1. **2022-005877-HDRB. 127 & 127 ½ E. DeVargas St.** Contributing. Dale Zinn, agent for Betty Caldwell Irrevocable Trust, Owner, proposes to remodel a 612 sq.ft. studio by adding a 180 sq.ft. portal and a 15 sq.ft. firebox, window, door, and yard wall alterations. (Angela Schackel Bordegaray)

Project Description: 2022-005877-HDRB. 127 & 127 ½ E. DeVargas St. Contributing. Dale Zinn, agent for Betty Caldwell Irrevocable Trust, Owner, proposes to remodel a 612 sq.ft. studio by adding a 180 sq.ft. portal and a 15 sq.ft firebox, window, door, and yard wall alterations. (Angela Schackel Bordegaray, asbordegaray@santafenm.gov)

DATE: November 8, 2022
TO: Historic Districts Review Board Members
FROM: Angela Schackel Bordegaray Senior Planner, Historic Preservation Division

Case # 2022-005877-HDRB

2a NORTH ELEVATION - PROPOSED
SCALE 1/4" = 1'-0"

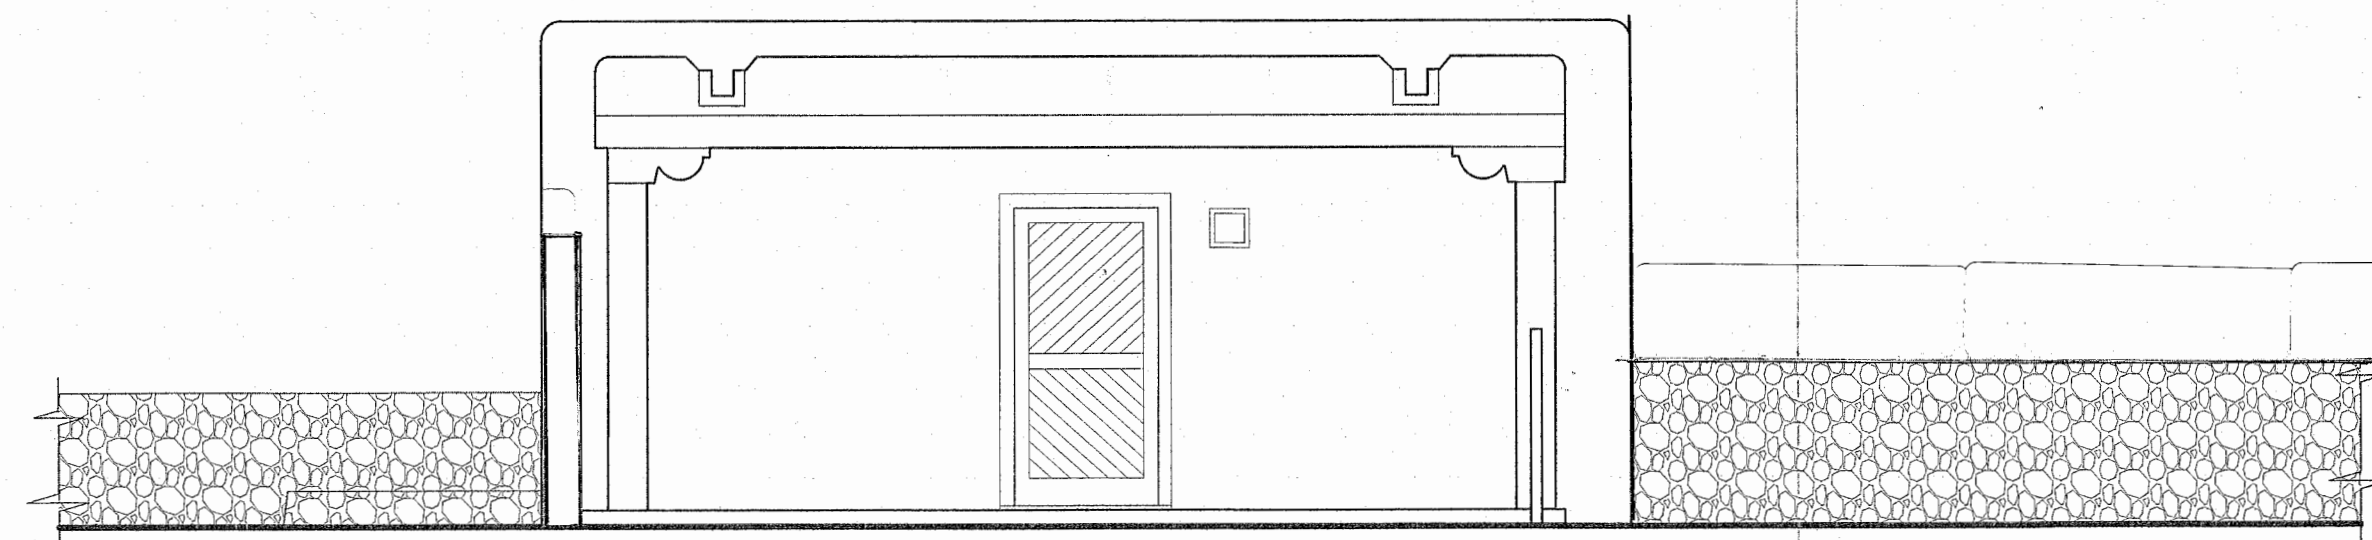
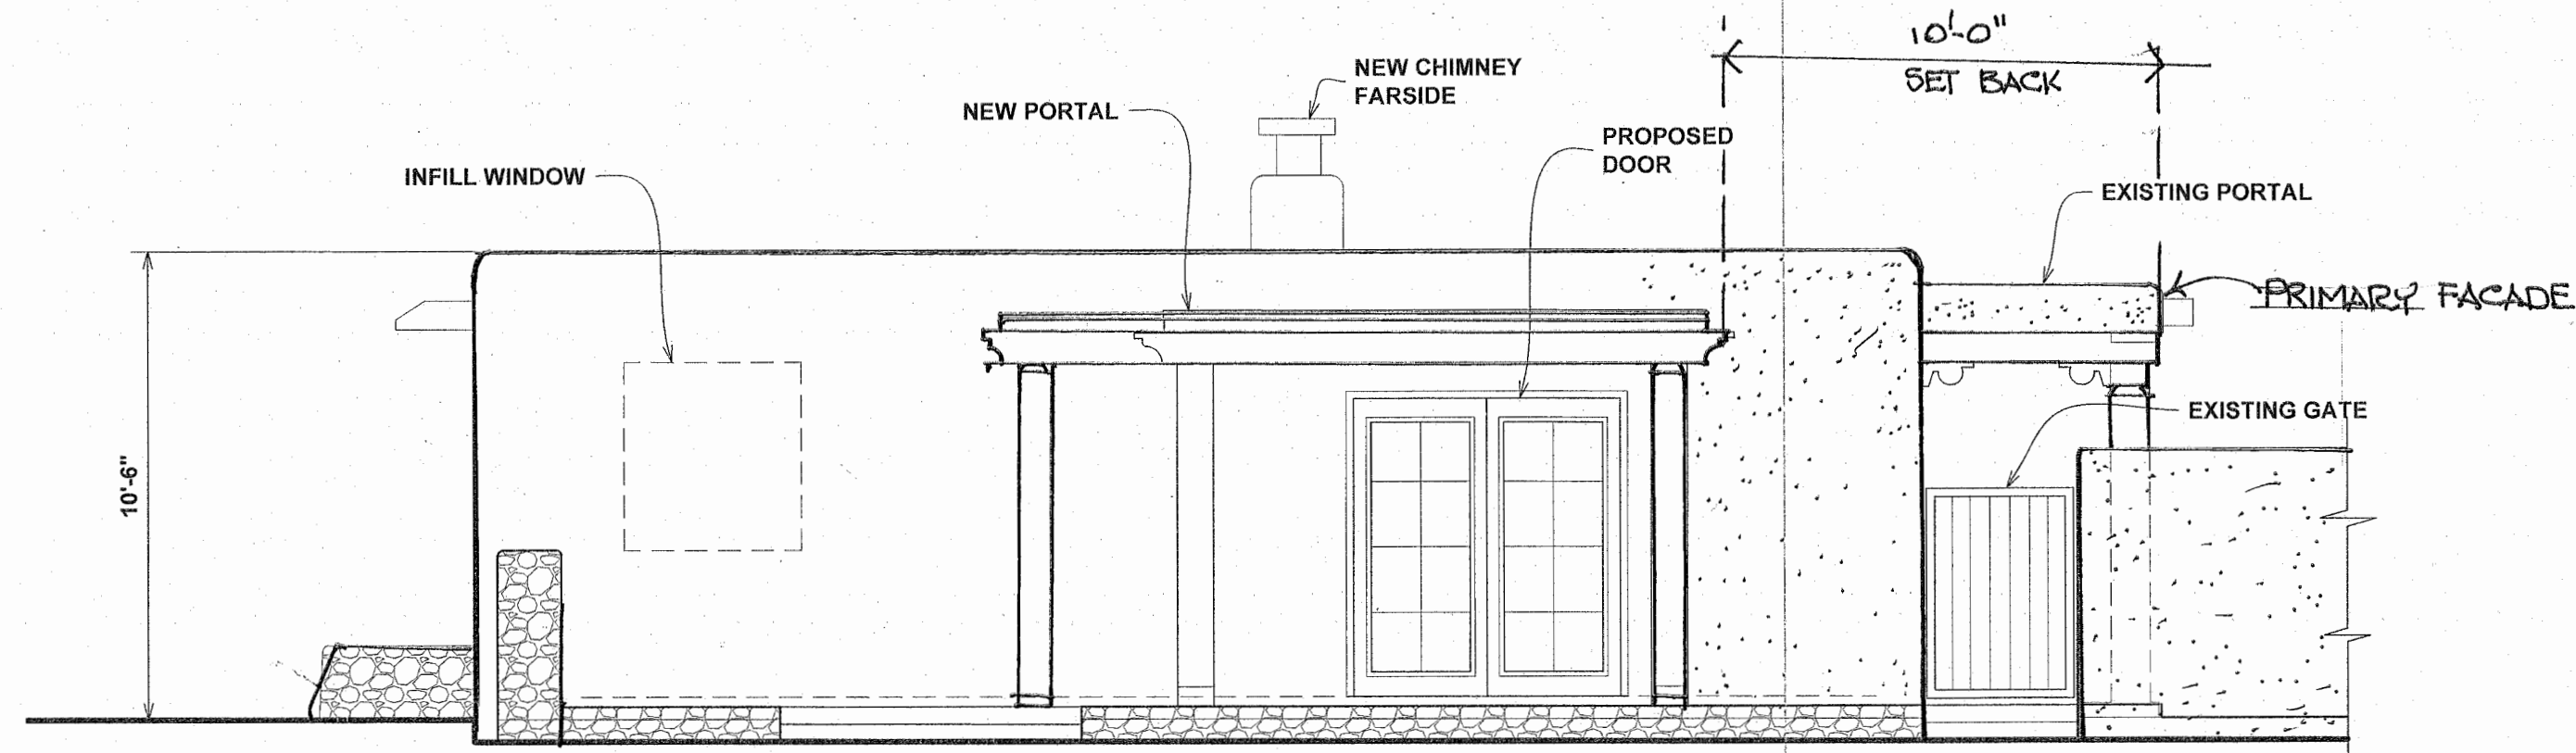
Staff recommended approval of the proposed project with the following conditions: that the proposed portal addition on the north elevation be set back at least 10’ from the west primary façade per Section 14-5.2(D)(2)(d) regarding proximity of additions to primary façades; and that the proposed stained-glass window meet Section 14-5.2 (E) (1)(c) regarding divided lites, as it exceeds 30” in width. Otherwise, staff finds that the application complies with Section 14-5.2(D) General Design Standards for all Historic Districts, and 14-5.2(E) Downtown and Eastside Design Standards.

Ms. Bordegaray said nothing, but the north façade is where the portal is proposed, which is less than 10 feet from mass.

Dale Zinn, PO Box 756 was sworn. He said the change to the portal is fine with the client and he will resubmit the drawings.

proposed portal be set back at least 10 feet from the primary façade, and the proposed stained-glass window meet section 14-5.2 (E)1(C) on divided lights, and that the applicant resubmit revised plans to staff for approval. The motion was seconded by Member Aguilar Medrano.

SOUTH WINDOW

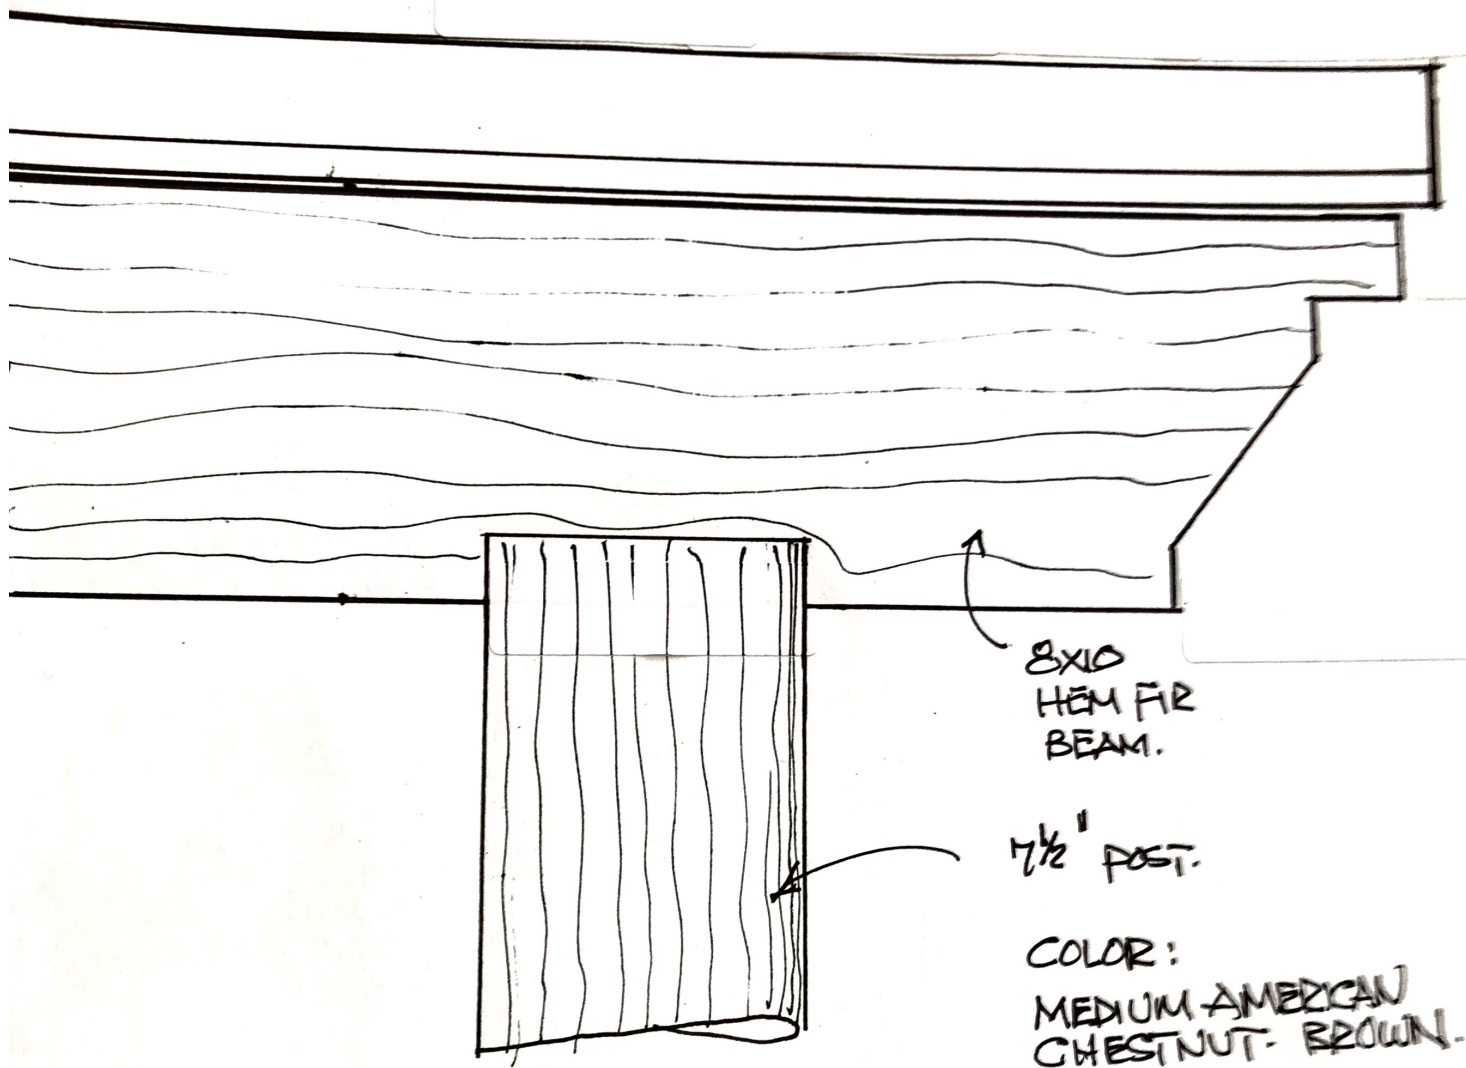
Member Bienvenu asked if he would provide divided lights on the stained-glass window.

Staff recommends approval of the proposed project with the following conditions: that the proposed portal addition on the north elevation be set back at least 10' from the west primary façade per Section 14-5.2(D)(2)(d) regarding proximity of additions to primary façades; and that the proposed stained-glass window meet Section 14-5.2 (E) (1)(c) regarding divided lites, as it exceeds 30" in width. Otherwise, staff finds that the application complies with Section 14-5.2(D) General Design Standards for all Historic Districts, and 14-5.2(E) Downtown and Eastside Design Standards.

Mr. Zinn said what is installed will meet criteria and is able to be cut down and will remain 30 x 30.

Angela..attached is a better sketch of the intended installation of the decorative window glass...we will put the glass..into a 24 x30 frame ...see attached
